**Scio Township Planning Commission Agenda**  
**Ann Arbor, MI 48103**  
**October 25, 2021, 7:00 PM**

**Preliminary Planned Unit Development Review  
For  
Scio Township, Michigan**

<b>Applicant:</b>	Nowak & Fraus Engineers / Jeff Huhta
<b>Project Name:</b>	Suburban Collection 2021
<b>Plan Date:</b>	February 15, 2021
<b>Revised Date:</b>	September 10, 2021
<b>Location:</b>	Northwest quadrant Jackson and W. Delhi Roads.
<b>Zoning:</b>	Western portion of the site is zoned I-1, Limited Industrial and the eastern portion is zoned R-2, Single-Family Residential. The property is also found within the Jackson Road Overlay District (JROD).
<b>Action Requested:</b>	The applicant is requesting Planning Commission review and recommendation for a Preliminary PUD to the Township Board pursuant to Section 36-249(d) of the Township Zoning Ordinance.
<b>Required Information:</b>	There are specific informational requirements for a preliminary PUD. We review the required information in detail in the sections below.

Application No: PUD-PSP #21003  
Applicant: Timothy Leroy  
Project Name: Suburban Collection  
Plan Date: February 15, 2021 Revision Date: September 10, 2021  
Location: NW corner of

SHEET  
 Boundary, Topographic, and Tree Survey - Area 1

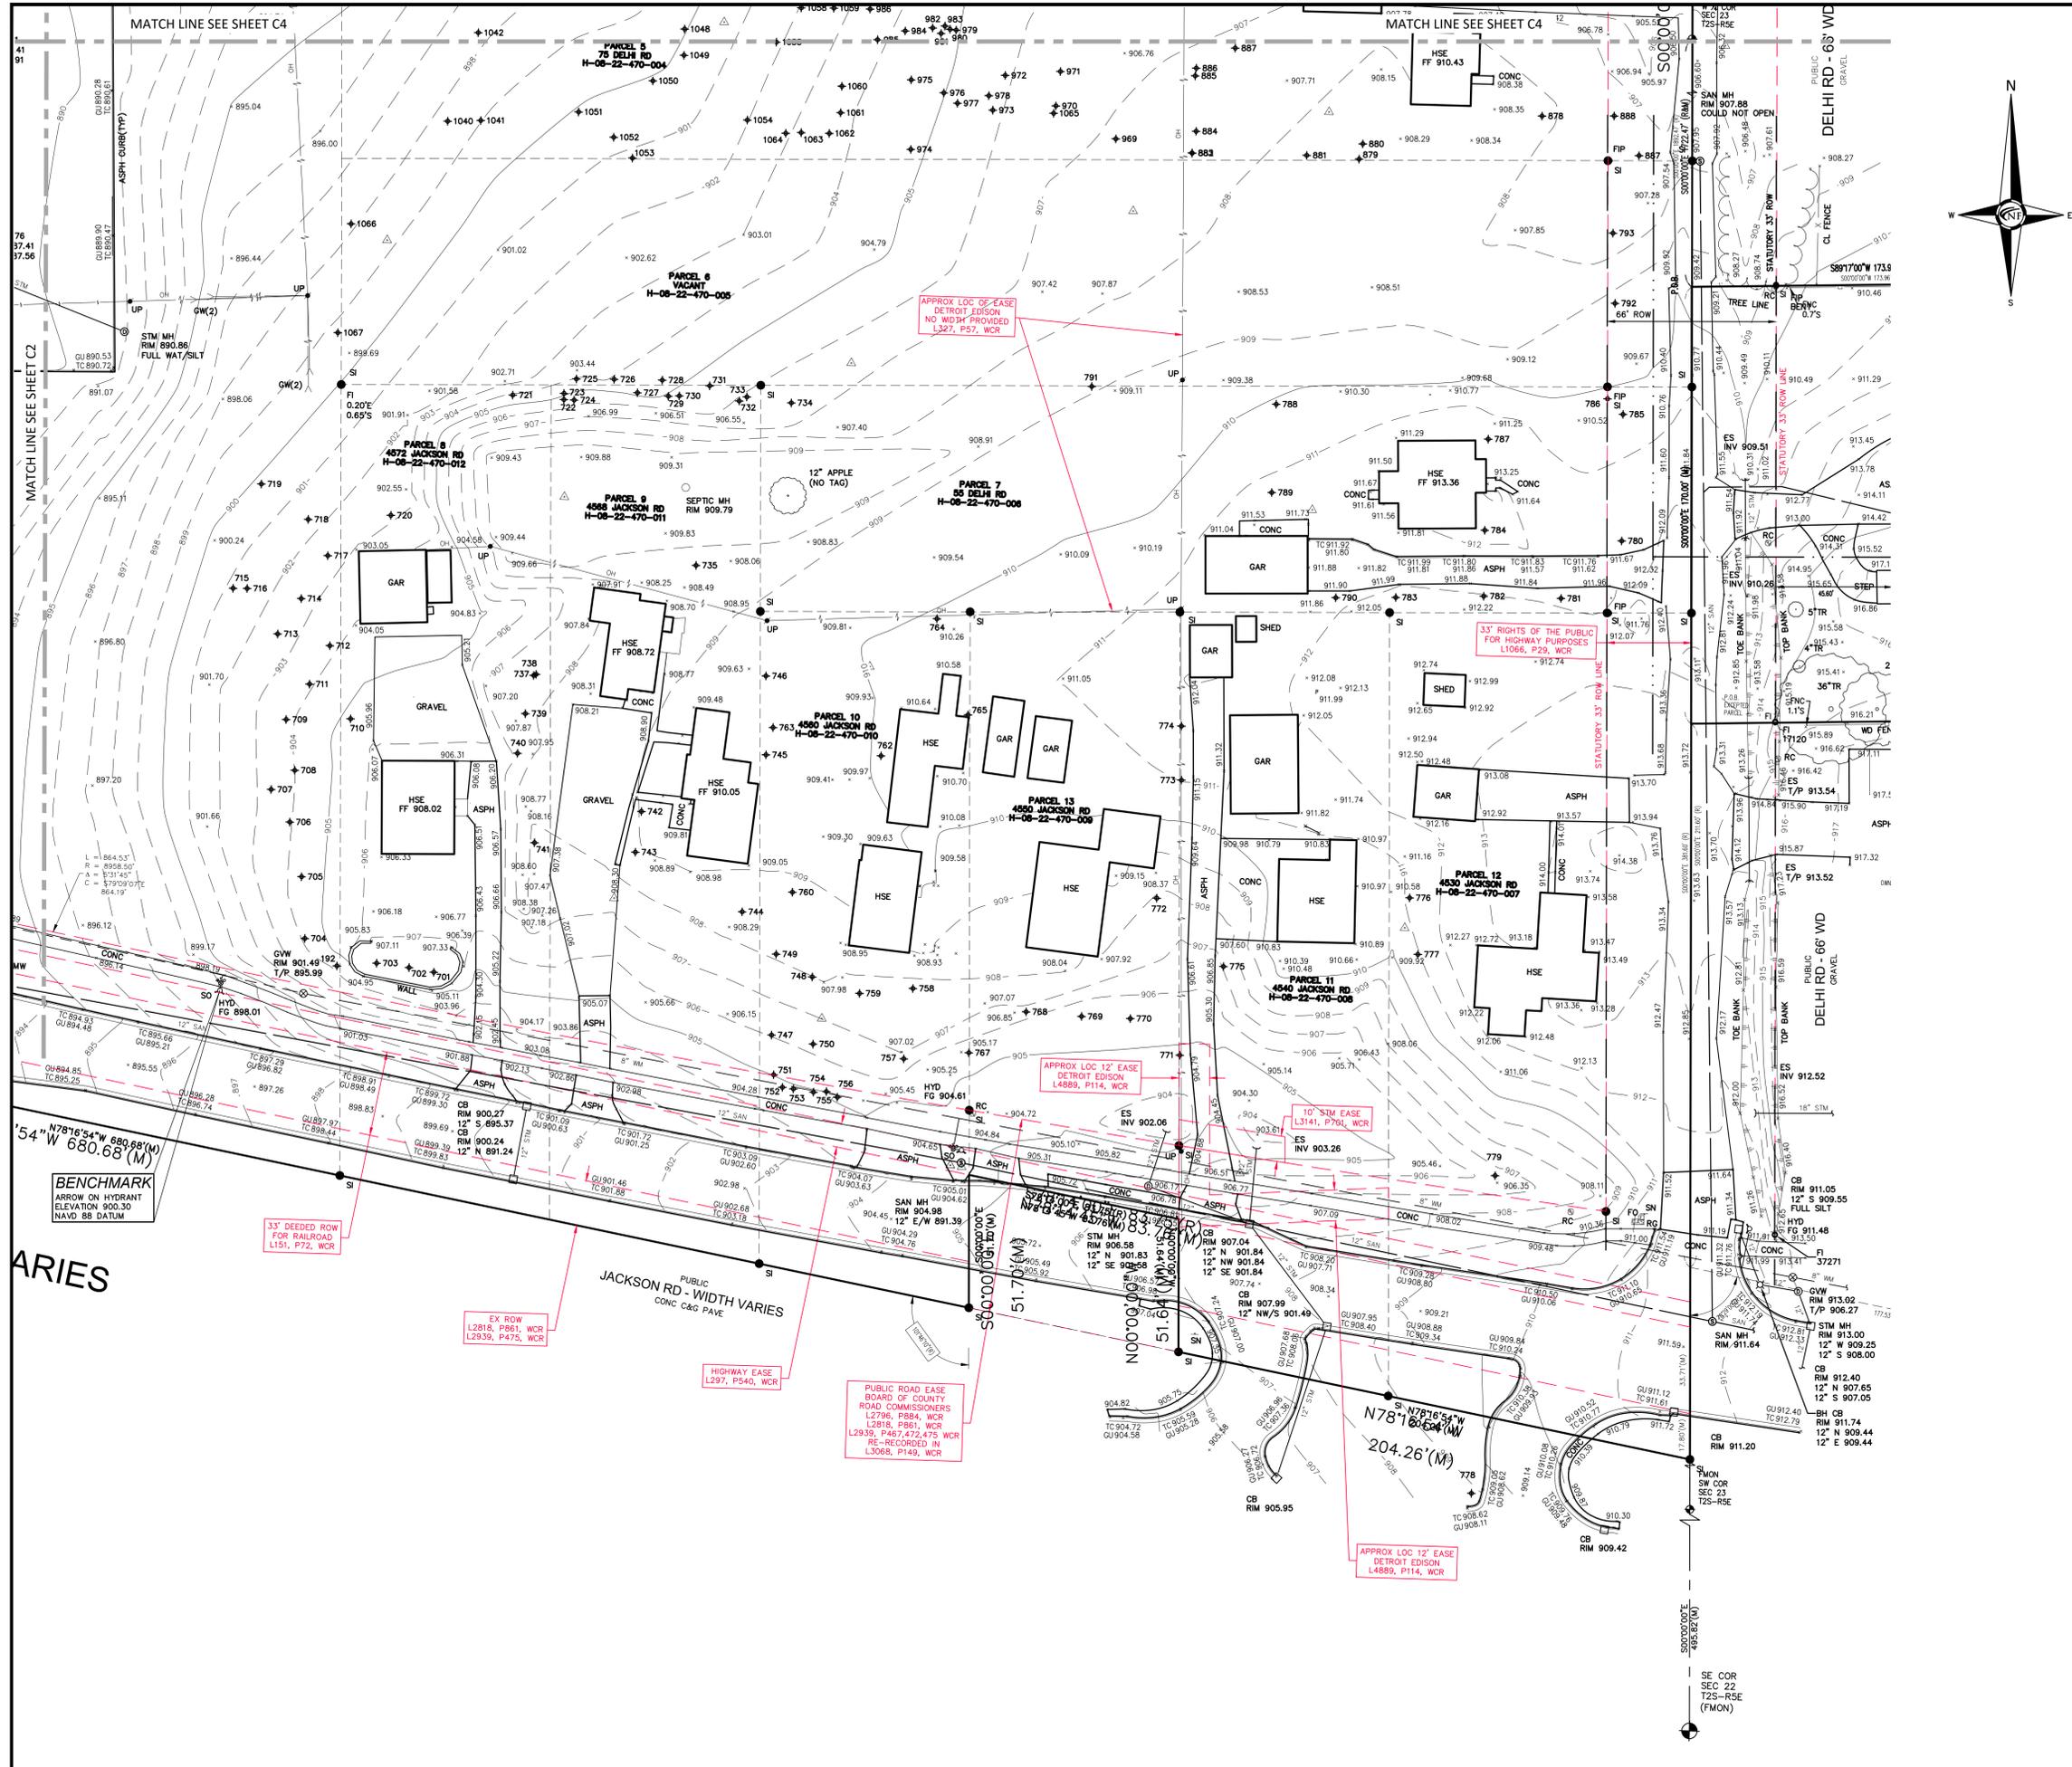
- Topography:** The site is undulating with the site sloping upward 32 from west to east.
- Wetlands:** No wetlands are noted to be located on-site.
- Woodlands:** A large portion of the site is covered by mature woodlands. A tree survey is provided on Sheet C-1 and a tree removal plan is provided on Sheet L-1. However, the tree list does not list which trees are proposed to be removed and we are unable to verify the tree replacement calculations provided. Further, the tree removal plan is difficult to read – tree labels are not clearly visible (Sheet L1). See Section 36-346(d) for tree removal/preservation plan requirements.

**Items to be Addressed:** 1) Provide tree removals on tree inventory list. 2) Clearly depict trees to be removed/preserved on the tree survey in accordance with Section 36-346(d). 3) Provide soil information on the site plan. 4) Indicate how soil constraints will be addressed.

SHEET  
 Overall Site Plan

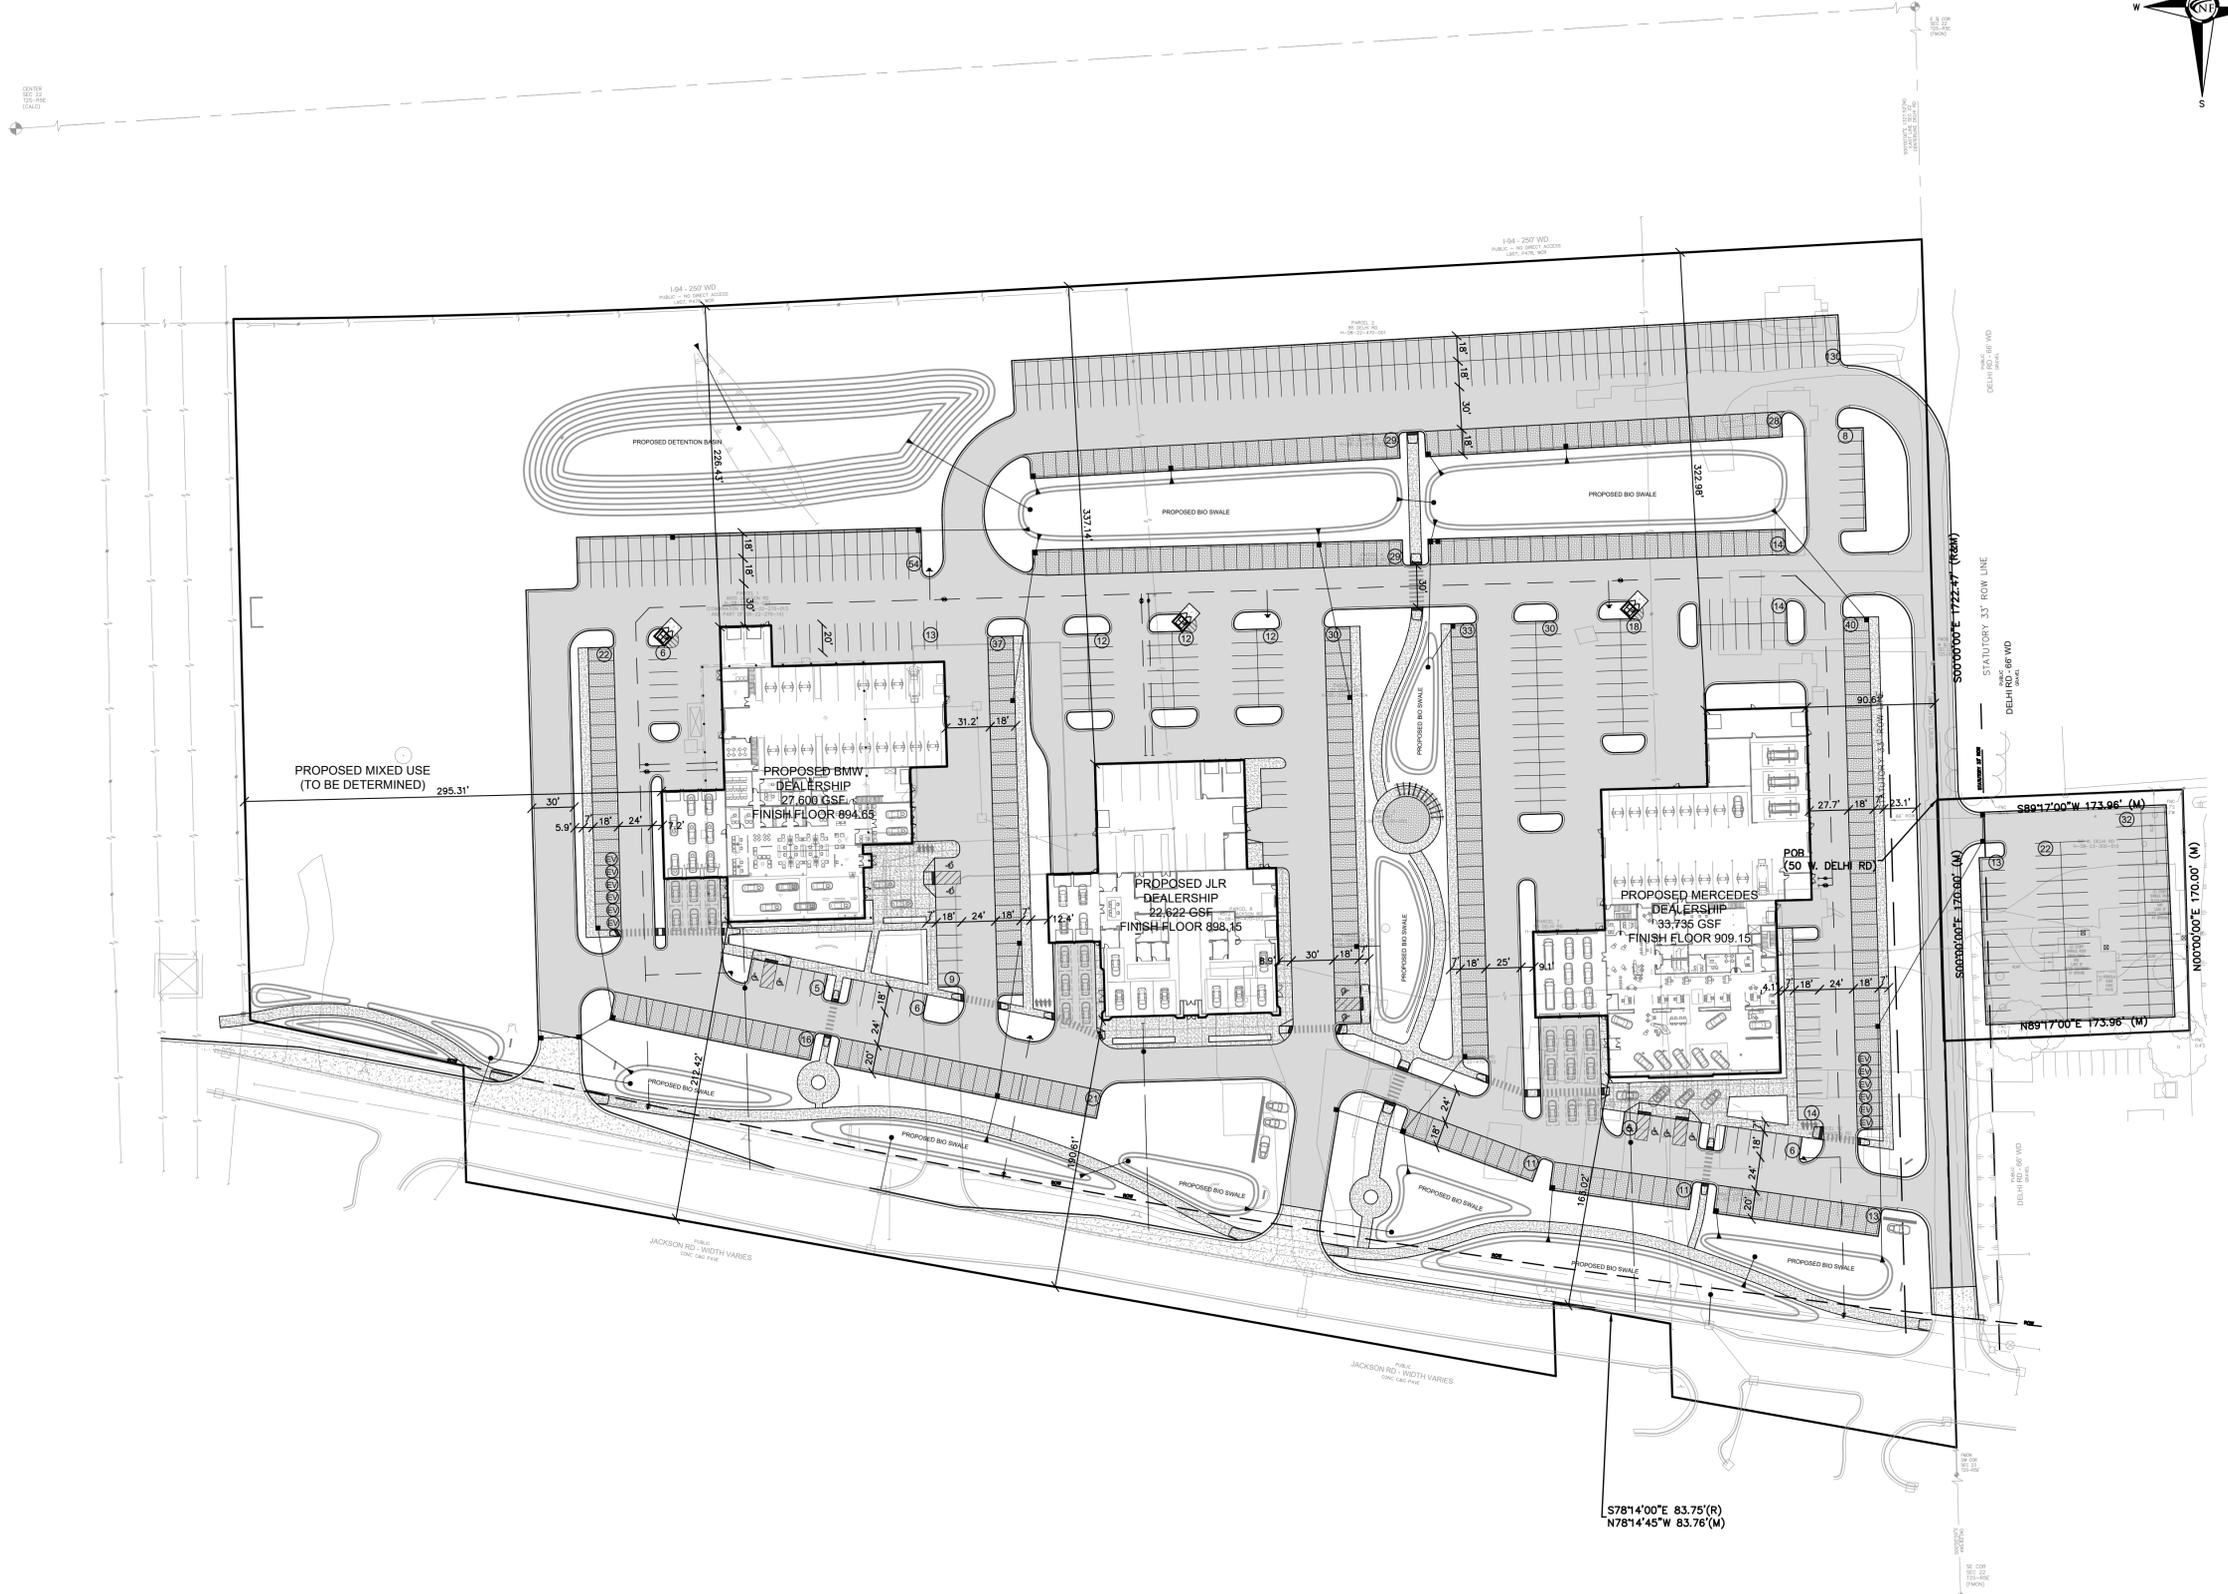
Parking calculations are provided on sheet C5. Section 36-278(h) requires auto sales uses provide one (1) parking space for each 200 square feet of showroom floor area plus three (3) per service stall. The applicant indicates the site will contain a total of 13,340 square feet of showroom and 48 service bays.

Based on the plans, there are a number of discrepancies in the parking numbers provided. Specifically, there four (4) parking space counts that are incorrect and one (1) location that does not provide any parking space count. We count the number of proposed parking/inventory spaces on the plan to total 771 spaces, not 763 spaces as noted in the site information on Sheet C5. Further, we note 340 spaces will consist of porous brick pavers and twelve (12) EV charging stations are provided.

**Items to be Addressed:** 1) Demonstrate which spaces will be parking versus storage. 2) Modify parking counts/site plan to depict correct number of spaces proposed. 3) Demonstrate proposed parking space widths. 4) Relocate barrier-free spaces at JLR directly adjacent to main entry. 5) Provide bicycle parking in accordance with Section 36-278(j). 6) Demonstrate loading/unloading area(s).
